**RE: Blanchard Oaks Subdivision, 365 Blanchard Road – Chris Axelson
Workshop Meeting**

Subdivision Type Recommendations for Blanchard Oaks

RE: Proposed Blanchard Road Ext Developments - potential impacts to local water supplies

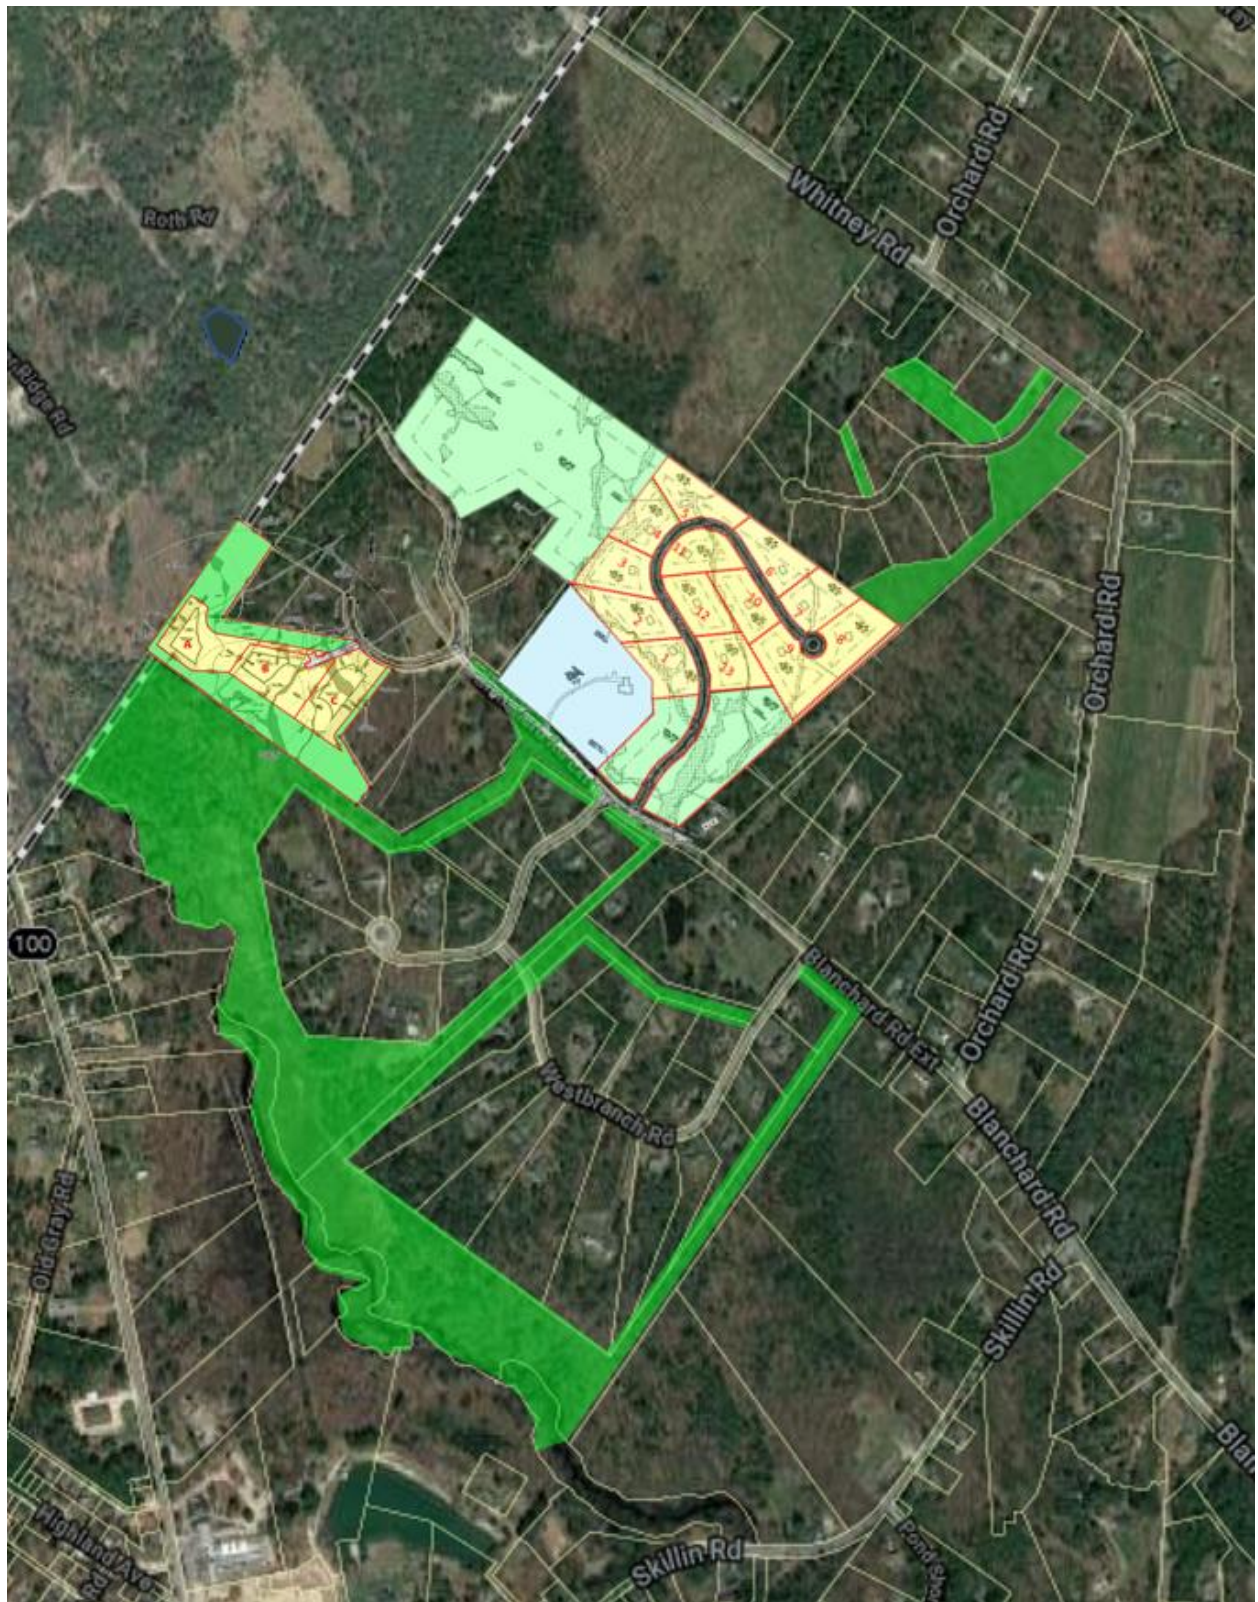
The proposed subdivision contains several streams, wetland areas, and three vernal pools. In addition, the subdivision borders on the open space of neighboring subdivisions. The proposed open space is broken into two parcels. In addition to protecting the streams, wetlands and vernal pools, the largest parcel (16.04 acres) will help protect wildlife habitat in the area. The smaller parcel of open space (6.68 acres) will help protect streams and wetlands. Between the two parcels, the 75 ft buffer surrounding the subdivision should serve as an adequate wildlife corridor connecting the two parcels, and will help protect the stream and wetlands in that buffer.

In terms of trails, the plan does not show any existing trails in the property. However, the LCC provided informal comments concerning the possibility of future trails based on the initial subdivision plan. These comments have been already been incorporated in the most recent plan. In particular, the most recent plan provides an easement for residents to access the larger area of open space and also a 15-ft wide corridor within the proposed open space that would connect to open space of a surrounding development (see map below).

Overall, the LCC believes the proposed development falls within the criteria for a Conservation Subdivision and thinks the developer is proposing a reasonable developmental plan for the subdivision. The LCC recommends that the Planning Board approve the proposed 13-lot Blanchard Oaks subdivision (plus 1 retained lot) as a Conservation Subdivision.
